Response to

Request for Additional Information No. 304 (3812), Revision 1

U. S. EPR Standard Design Certification
AREVA NP Inc.
Docket No. 52-020
SRP Section: 05.03.01 - Reactor Vessel Materials
Application Section: 5.3.1

Question 05.03.01-12:

Figure 05.03.01-12-1—Weld Between the RPV and the Radial key

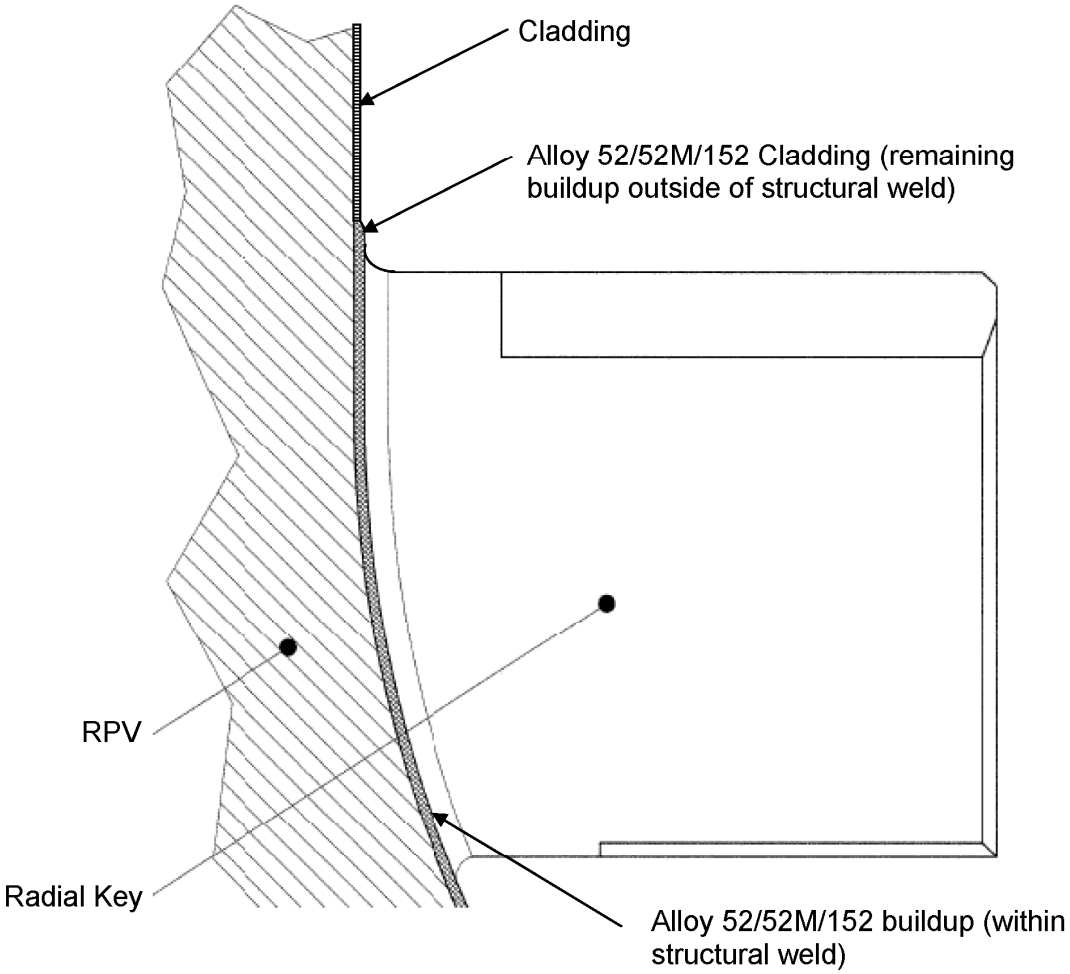
In response to RAI 2761 Questions 05.03.01-10, the applicant stated that 309L/308L stainless steel and Alloy 52/52M/152 cladding is deposited for the full clad thickness, and that the nominal cladding thickness of 0.295 inches applies to the total cladding thickness regardless of cladding material. The applicant also stated that this thickness applies only to cladding. As an option, the cladding may be qualified as weld buttering and additional thickness requirements may apply, as addressed in the response to Question 05.03.01-11b. However, the NRC staff notes that AREVA's response to Question 05.03.01-11b did not state the additional thickness requirement for the U.S. EPR design, but only used a specific fabrication sequence for a particular reactor vessel with a weld buttering thickness of 0.39 inches minimum, and, as such, might not reflect the fabrication sequence to be used for the U. S. EPR design. In addition, AREVA stated that in accordance with QW-283 of the ASME Code, Section IX, the minimum qualified buttering thickness is specified in the qualified weld procedure, and that qualification of the welding procedures and processes in accordance with ASME Sections III and IX provides acceptable controls to ensure integrity of the RPV low alloy steel base metal is not adversely affected by welding of the radial keys.

The NRC staff notes that the minimum weld buttering thickness specified in a welding procedure is based on the thickness used during the procedure qualification test. But, the design buttering thickness is also based on the design of the reactor vessel and the core support structures in accordance with ASME Code, Section III to account for stresses, including thermal stresses, bearing loads, etc., and should not be solely dependent on the fabrication methods (welding procedures or processes). Therefore, AREVA is requested to provide additional design thickness requirements for the weld buttering option, and include these requirements in the EPR FSAR. This is to ensure that the design of the reactor vessel accounts for the weld buttering, and that the low alloy steel reactor vessel is not adversely affected by heat input after welding of the radial key structural attachment weld is completed without post weld heat treatment of the low alloy steel reactor vessel.

There is no design thickness for the weld buttering by itself, only a qualified thickness. The only design thickness is for the completed weld between the radial key and the RPV internal surface, which is specified to be a full penetration weld. A clarification will be added to U.S. EPR FSAR Tier 2, Section 5.3.1.2, which will revise the RAI 232, Question 05.03.01-11a added text, to indicate that the weld between the RPV and the radial key is a full penetration weld.

The final profile of the weld between the radial key and the RPV internal surface/adjacent cladding will be obtained with a radius transition (see Figure 05.03.01-12-1). When providing this transition, the majority of the deposited buttering material that is not within the volume of the structural weld will be removed.

In the event that additional thickness of deposited Alloy 52/52M/152 weld material (beyond that required for cladding) remains outside the area of the structural weld (see Figure 05.03.01-12-1), the presence of this material will not have a significant adverse impact. The additional thickness is expected to be minimal (nominally less than 0.1 inch increase based on the vessels under fabrication for European plants). As the thermal expansion of the Alloy 52/52M/152 weld material is closer to that of the low alloy steel pressure boundary material than the adjacent stainless steel cladding, no significant increase in thermal stress is anticipated.

The total thickness of the weld buttering (nominally 0.39 inch for vessels under fabrication for European plants) represents less than four percent of the total component thickness (nominally 9.84 inches at the thinnest part of the transition ring at the location where the radial keys are attached). Although this specific provision is not utilized in the evaluation of the U.S. EPR RPV, ASME Code Section III, NB-3122.3 states that when the cladding is integrally bonded and the nominal thickness of the cladding is 10 percent or less of the total thickness of the component, the presence of cladding may be neglected altogether.
